OROVILLE EMERGENCY RECOVERY – SPILLWAYS

Board of Consultants Memorandum

DATE: May 20, 2019

SUBJECT: Memorandum No. 23

Figure 1. Photographs Taken During BOC Inspection of FCO

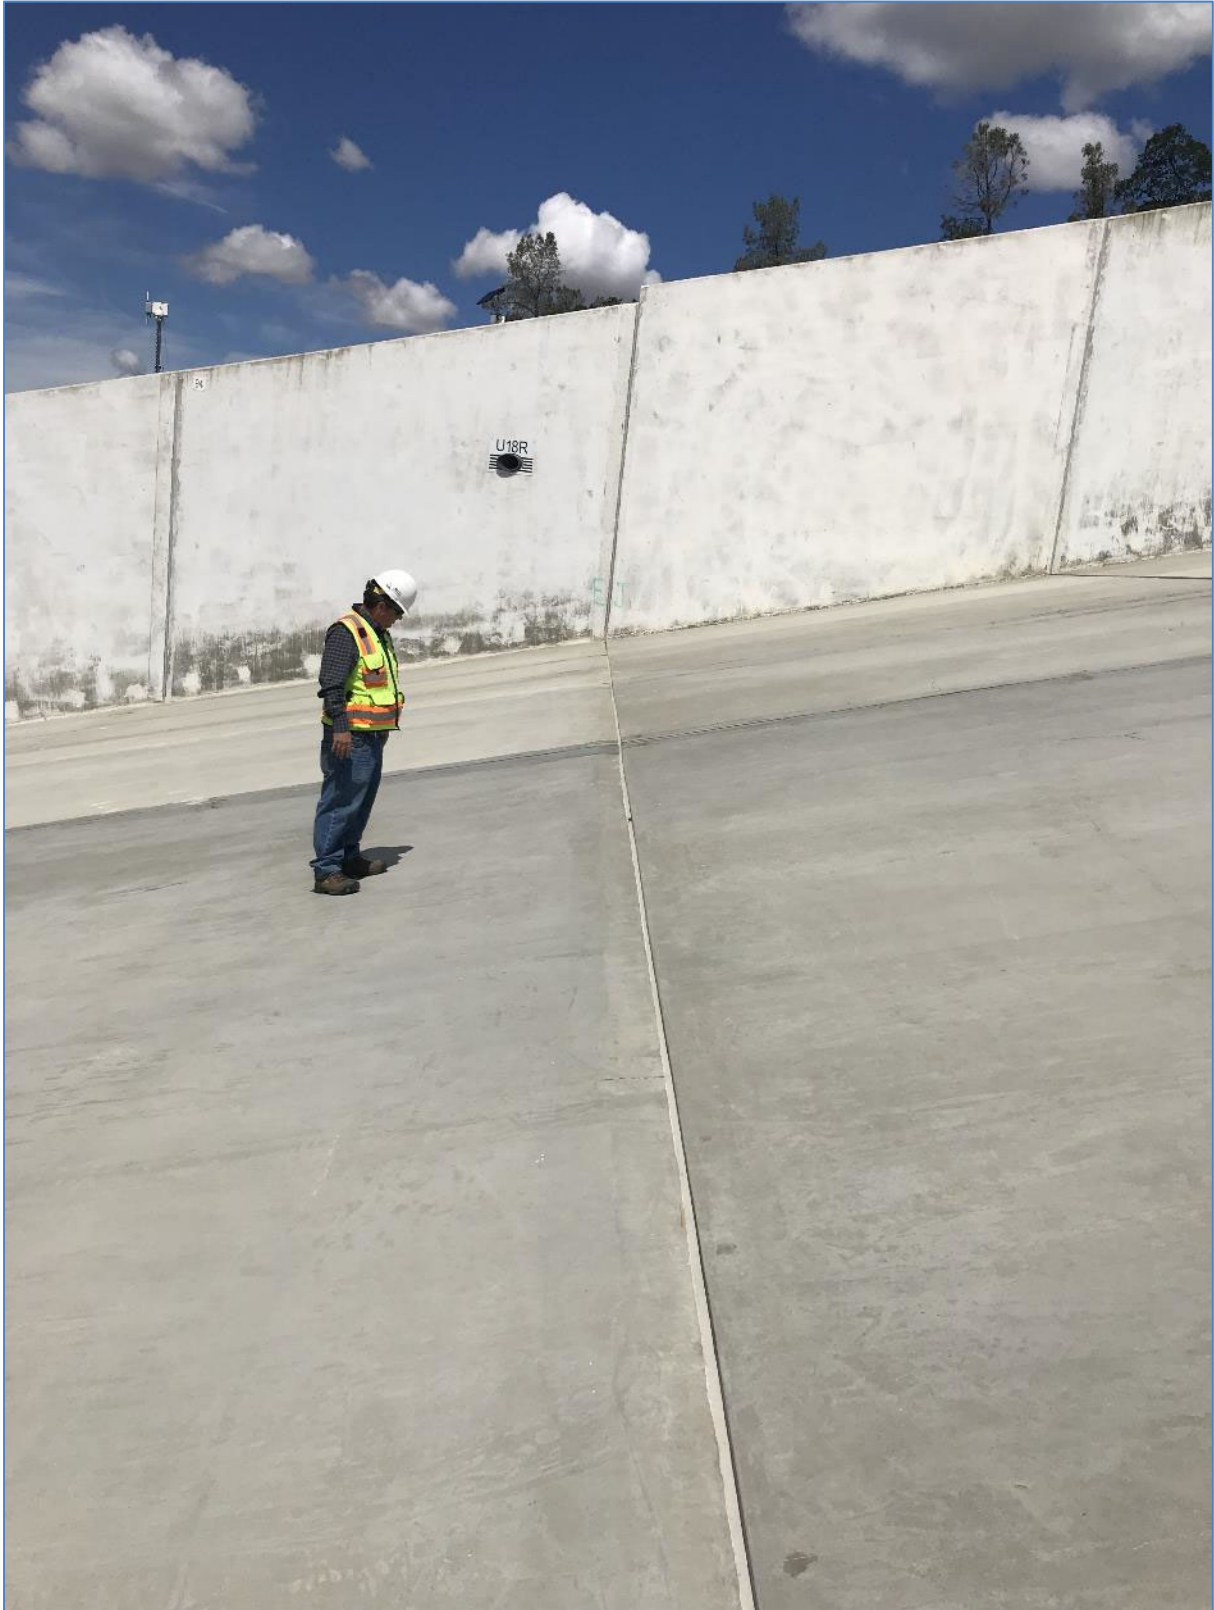
The BOC inspected the full length of the FCO Spillway on May 20, 2019 from inside the spillway. Select photographs taken by BOC members are presented on Figures 1 through 5. Collectively, the BOC noted only minor cosmetic differences from when the FCO spillway was inspected prior to passing flow. The differences included a handful of transverse joints missing several inches of flexible sealant, a spalled shallow small concrete repair, and a roughened surface of a slab finish (see photographs in Figures 4 and 5).

On the basis of its close involvement in the review of design documents, its knowledge of the foundation conditions and materials used in construction, its observation during the various phases of construction, and the satisfactory performance of the spillway during the first operational release, the BOC affirms that the reconstructed Oroville Spillway has been completed in accordance with the design documents, and is judged to be safe for continued use.
